AMENDMENT TWO (2)

**SUBJECT: IFB008DPWC17 (C) East Scenic Road Phase II
Pavement Preservation and Drainage
Improvement, St. Croix District.**

Pre-Bid Questions

DETAIL
INLET TYPE 5B WITH
4'X4' METAL FRAME & GRATE

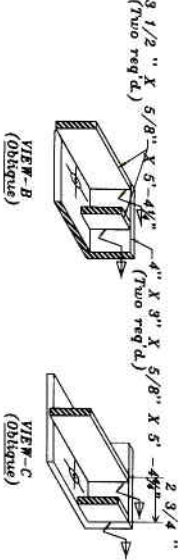
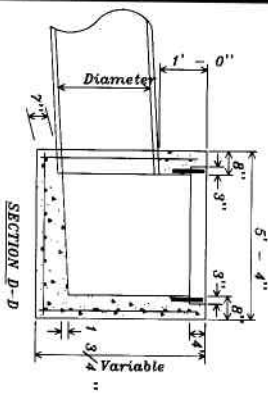
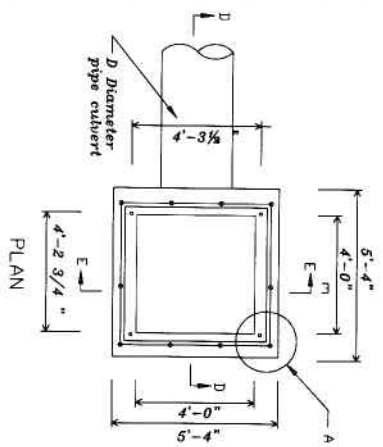
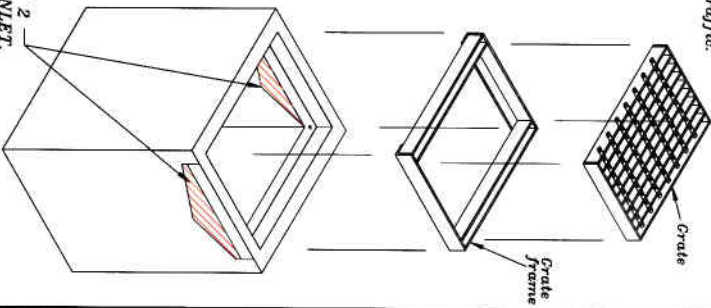
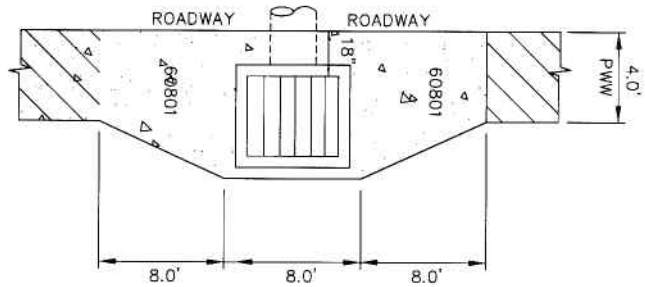
2. Project plan sheets call for slots to be added to inlets. Details are required for DBE take offs. Please provide detail drawings for the additional slots to be installed in catch basins.

3. For line item 604.01 A & B, please provide a detail for the transition from line item 608.01, Paved Waterway, to each type of catch basin. Details are required for DBE take offs.

2. This is a minor field change to be made to the catch basin. The sizes vary from location to location nevertheless please see the detail sheets attached.

3. Our response is the same as item 2 above.
4. Brush cutting will be done by DPW prior to start of construction to clear the areas for roadway excavation.
